## STAFF RECOMMENDATION 901 Gilmore Ave May 18, 2016

**Application:** New construction – addition and detached accessory dwelling unit;  
Setback determinations

**District:** Waverly Belmont Neighborhood Conservation Zoning Overlay

**Applicant:** Lightfoot Graham Development, LLC

Figure 4: 1957 Sanborn

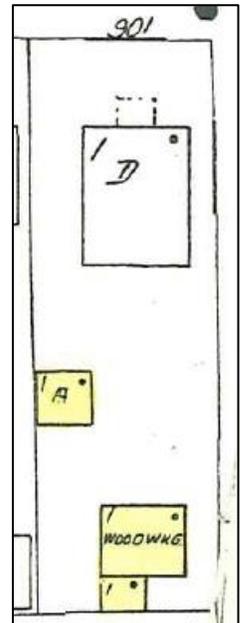
The DADU meets all setbacks except for the rear for which the applicant has requested a setback determination. Since the footprint of the DADU exceeds seven hundred (700 sq. ft.), the required rear setback per the Zoning Code is twenty feet (20'). The applicant requests that the rear setback be reduced to ten feet (10'). Staff finds that the proposed rear setback is appropriate as it is consistent with other outbuildings in the immediate area and locating the outbuilding closer to the property line is historically appropriate. Sanborn maps from 1957 show an accessory dwelling unit on this site that is located in the rear yard close the alley. (See Figure 4.)
